**Capital Development Committee**  
State Capitol Building, Room 029  
Denver, Colorado 80203-1784  
(303) 866-3521

**Table 1**  
**Capital Development Committee Recommendation**  
**Regarding Facility Program Plan**

**Department of Corrections**  
**Capital Development Committee Staff Questions**

Facility Program Plan for Outdoor Recreation Spaces, Colorado State Penitentiary

**CSP - SITE PLAN**  
**RECREATION YARD PROJECT**

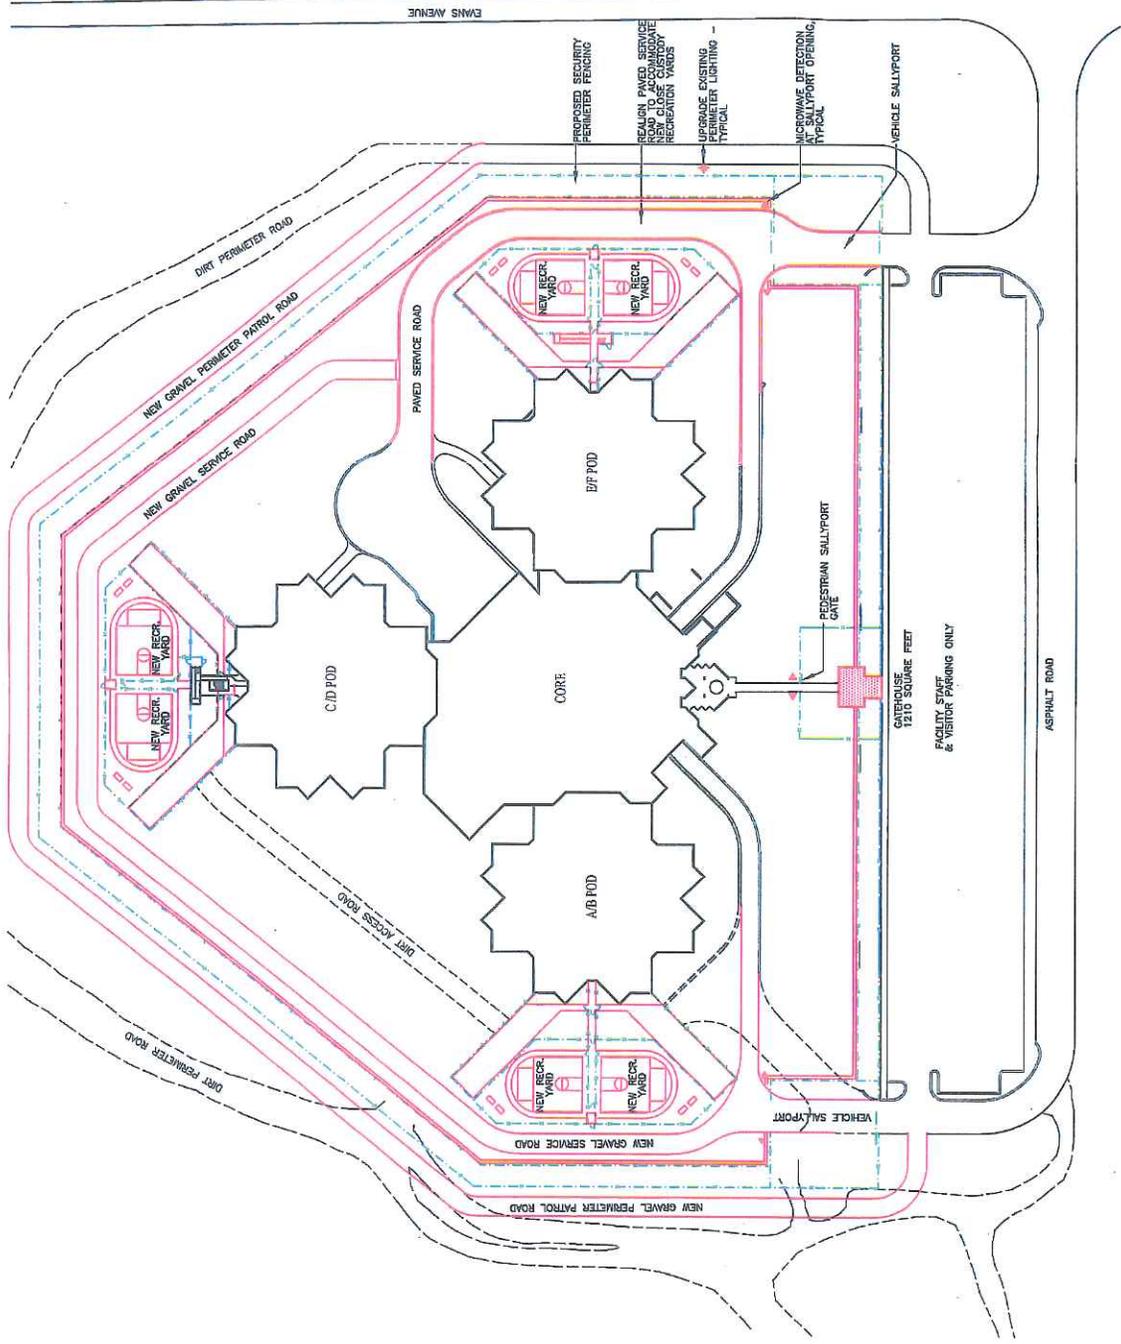
8. Why is it not practical to place the second 12-foot high security fence outside the entire length of the existing fence?

Will the appropriate level of detection and deterrence for a Level V facility be provided in the areas that do not have a double line fence?

Where there is not a second fence, will razor ribbon wire and barbed wire be added to the existing fence?

*Answer: A double 12-foot high security fence surrounding the entire CSP complex has been proposed for the project; refer to "Appendix B-Preliminary Site Plan Concepts" located in the FPP. In some areas the configuration of the existing single security fence does not make it practical to install the second security fence due to security issues or limited space for the outdoor recreation yards and perimeter road. In these locations the existing single fence will need to be reconfigured to allow for sufficient installation of the second fence.*

*Answer: The double fence will enclose the entire perimeter and with its security features is intended to provide the appropriate level of detection and deterrent for a Level V facility when offenders are regularly outdoors in close proximity to the perimeter. The double fence line includes the following features:*

- *Razor ribbon wire in a coiled pyramid array at base of the new outer security fence*
- *Barbed wire and supports at top of new outer fence*
- *Horizontal concrete rat barrier inside of existing inner fence*
- *Two vehicle sallyports with remote operated sliding gates*
- *Non-lethal electrified fence (NLEF) on inner security fence.*

*Answer: A second fence with razor ribbon wire in a coiled pyramid array at the base of the new outer security fence is planned for the entire complex.*
